From: Gonzales, Rafael [mailto:rjgonzales@STPEGS.COM]
Sent: Thursday, May 04, 2017 10:11 AM
To: James, Lois <Lois.James@nrc.gov>
Cc: Aldridge, Arden J <ajaldridge@STPEGS.COM>
Subject: [External_Sender] STP response to ACRS questions

Below are responses to the questions from the ACRS subcommittee meeting:

Availability of Cathodic Protection System in the Protected Area

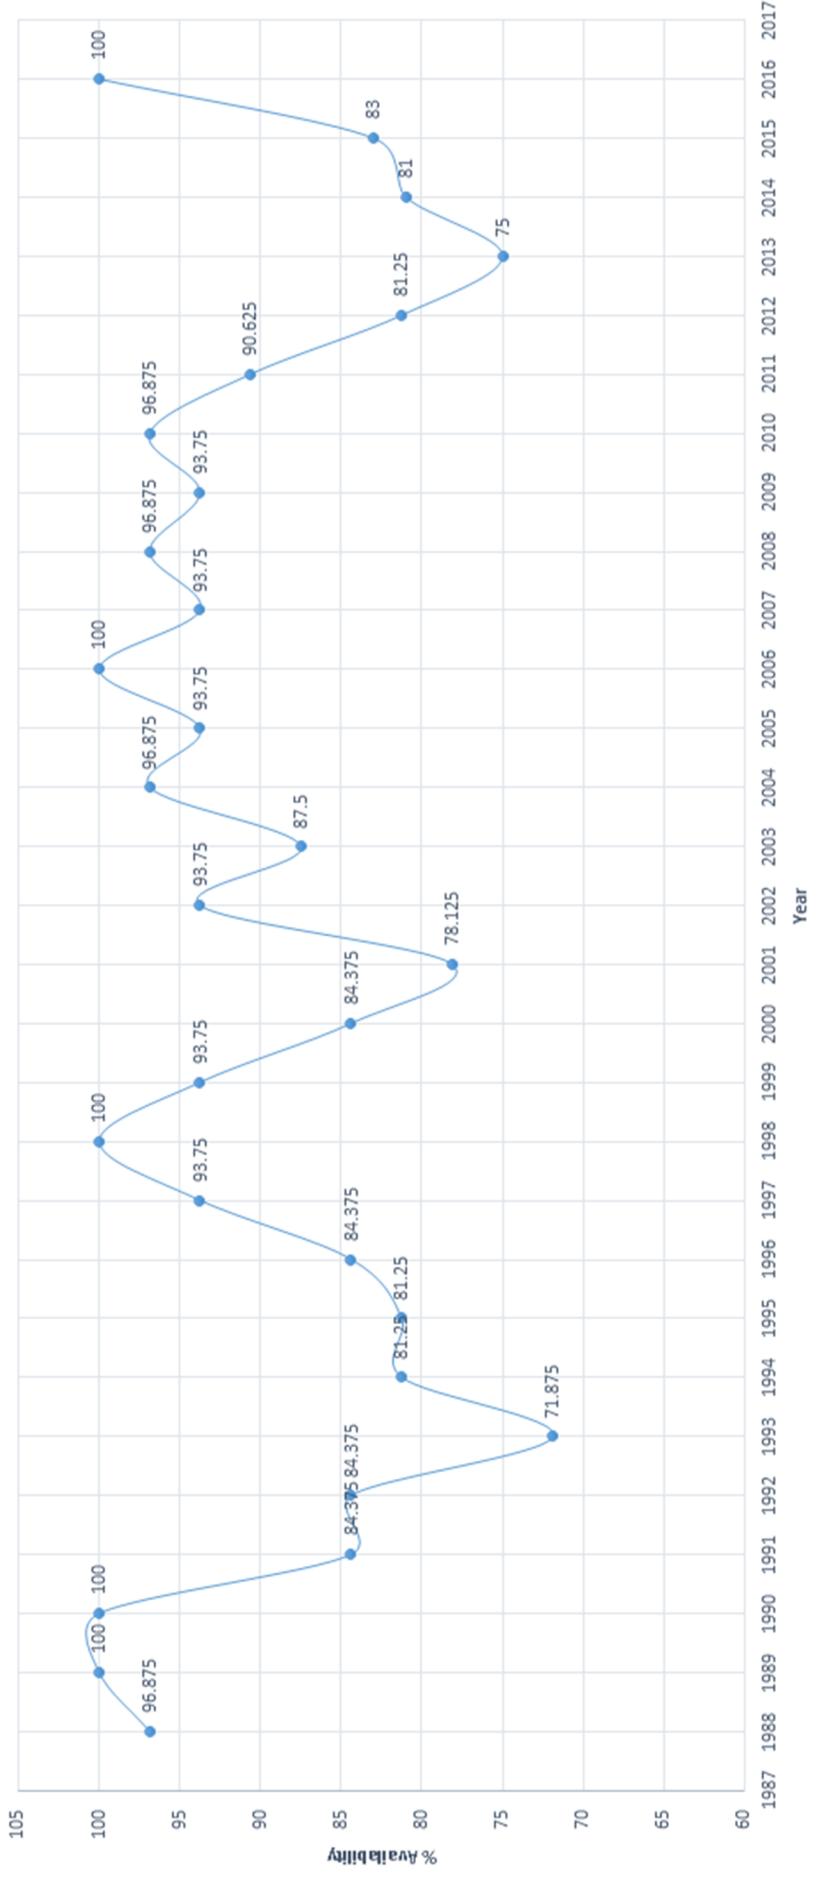
Question 1: (ACRS Member Stetkar) What has the historic availability over the life of the plant of you cathodic protection system been?

The historical availability over the life of the plant of you cathodic protection system is as follows:

For the years 1988 to 1993, the data has been obtained from the preventive maintenances performed on al 16 rectifiers installed in the protected area. For the years 1994 to 2016, the data was obtained from 2 annual preventive maintenances (i.e. 93001319 and 94002738) performed on the system rectifiers to adjust/repair and pipe-to-soil potential surveys. It is best to consider the availability by individual year but the system maintained a lifetime average of 89.6% availability.
